# COMMUNITY DEVELOPMENT DEPARTMENT REPORT

APPLICANT: Laren Bailey, DevCo

SUBJECT: H-2024-0068  
Adero Mixed-Use Neighborhood MDA,  
PP, RZ

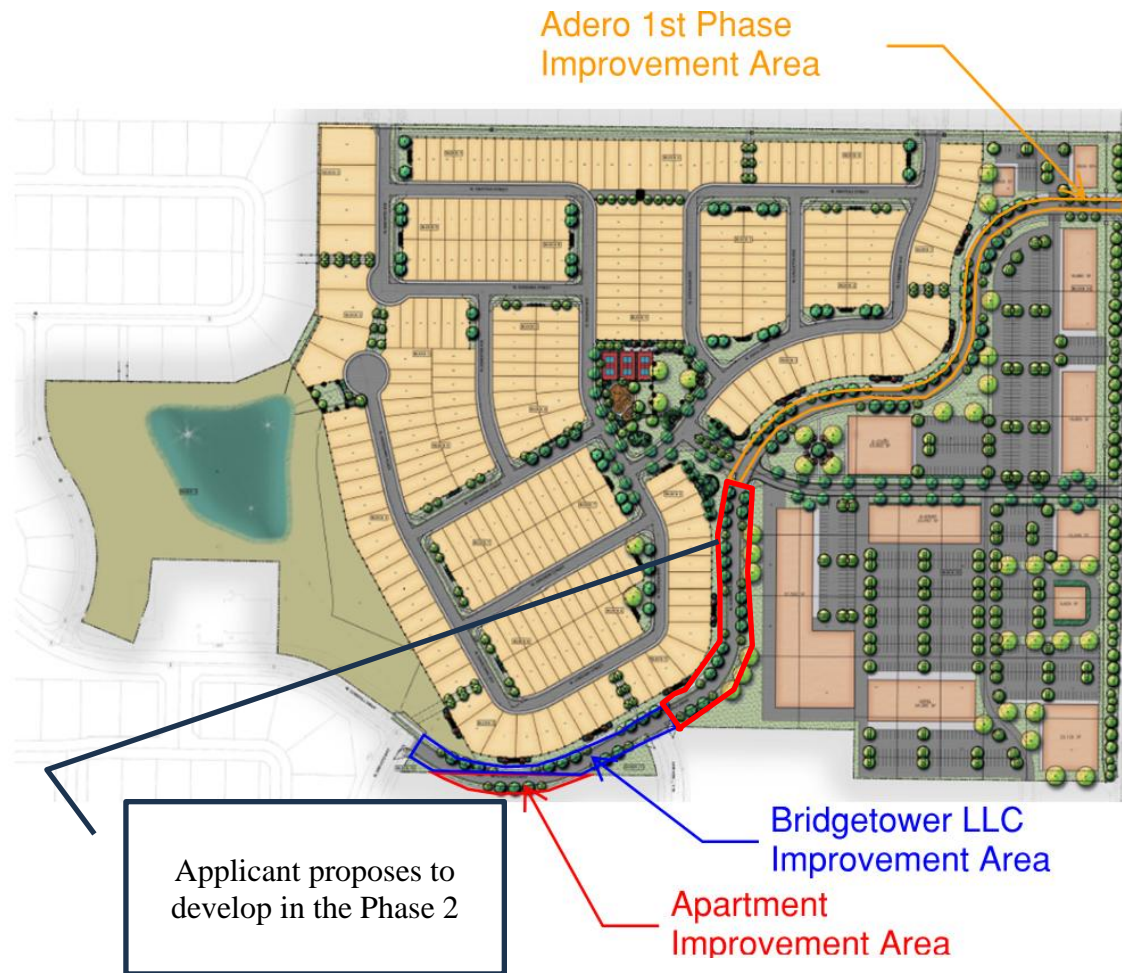
**Collector Street:** The collector street (W. Malta Drive/W. Gondola Drive) shall be developed as a three (3) lane collector street (either a 47-foot wide or 37-foot wide street section) at its intersection with Ten Mile Road within the influence area of the intersection. West of the intersection, taper the roadway to 2 lanes as follows:

- Construct W. Malta Drive/W. Gondola Drive as a 36-foot wide residential collector street section with 2- travel lanes, on-street bike lanes, vertical curb, gutter, a minimum 8-foot wide landscape strip and 5-foot wide detached concrete sidewalk; or
- Construct W. Malta Drive/W. Gondola Drive as a 26-foot wide residential collector street section with 2- travel lanes, vertical curb, gutter, a minimum 8-foot wide landscape strip and a minimum 10-foot wide multi-use pathway on both sides of the roadway.
- The multi-use pathway will need to transition to on-street bike lanes at the intersection of W. Malta Drive/W. Gondola Drive and San Vito Way.

W. Malta Drive/W. Gondola Drive shall be constructed as a completed street (travel lanes, curb, gutter, sidewalk and landscaping). Staff is recommending these improvements be included with Phase one (1) of the development.

### **G. Commercial Access and Pedestrian Plan (date: 5/8/2025)**

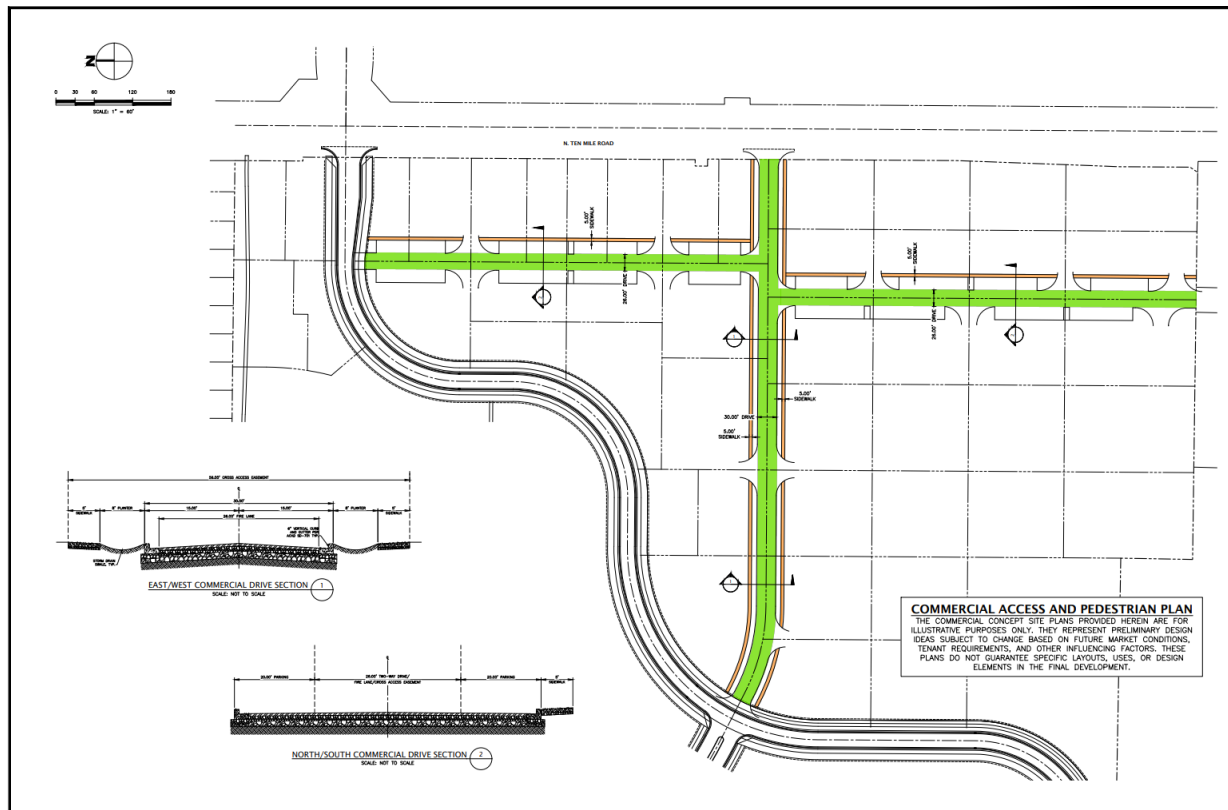
- p. No additional driveways shall be permitted on the new collector, except for those explicitly identified and approved as part of this application.
- q. Pedestrian circulation and cross access shall generally conform to the layouts depicted in the concept plans provided in Exhibits VI.G and VI.M.

### M. Pedestrian Connectivity Exhibit

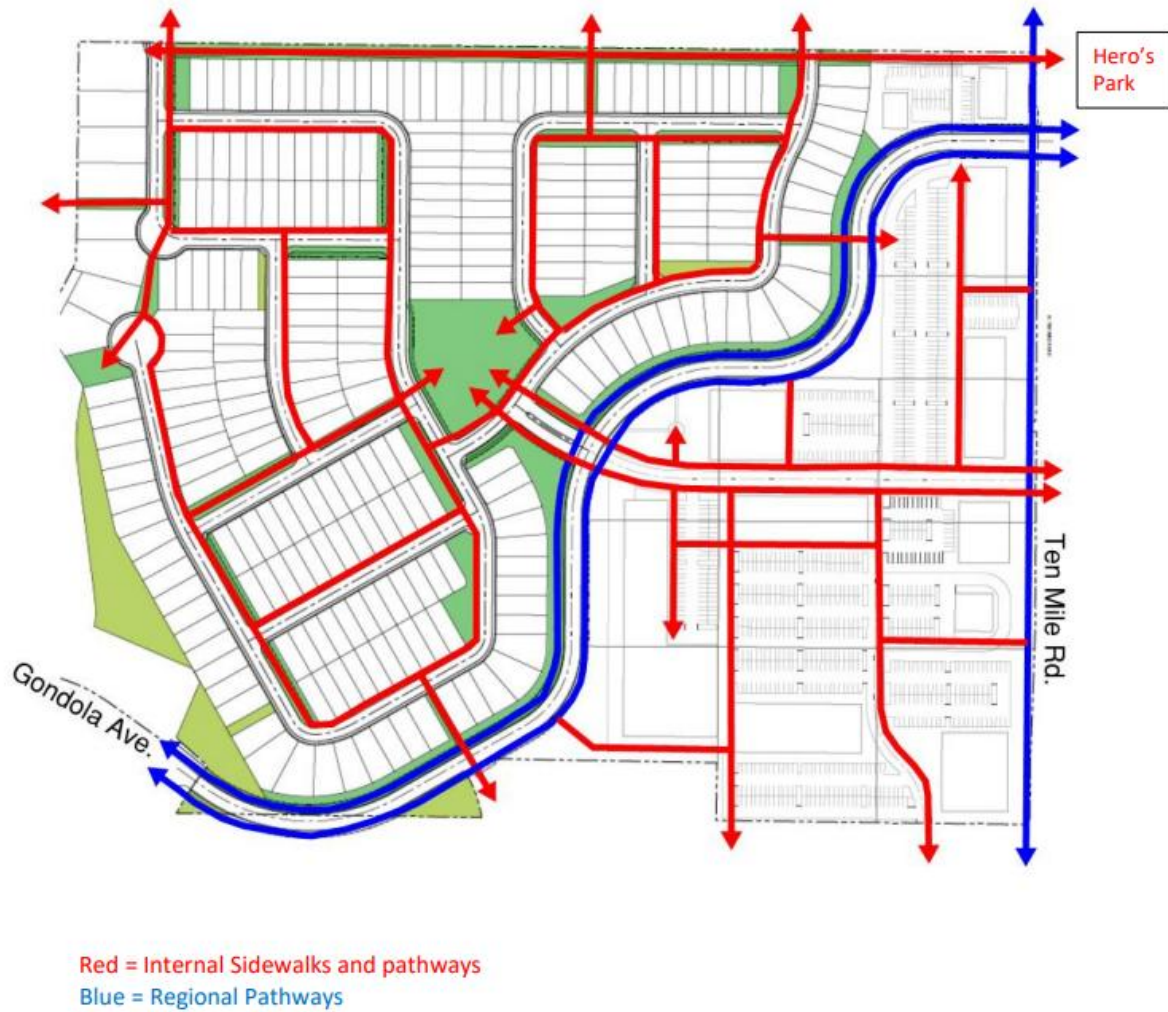
4. Multiuse Pathways (*UDC 11-3A-5*):  
*Multiuse pathways shall be constructed in accord with the city's comprehensive plan, the Meridian Pathways Master Plan, the Ada County Highway District Master Street Map and Roadways to Bikeways Master Plan.*  
*A ten (10) foot wide detached pathway is reflected along W. Malta Drive/Gondola Drive which is consistent with the alignment shown on the Pathways Master Plan. There is a five (5) foot wide detached sidewalk along Ten Mile Road which is consistent with Ada County Highway District Master Street Map and Roadways to Bikeways Master Plan.*  
*Several micro-pathways are reflected providing connectivity to internal portions of the development. As mentioned in the Comprehensive Plan analysis above; to improve more direct pedestrian connectivity, staff is recommending additional micro-pathway connections.*
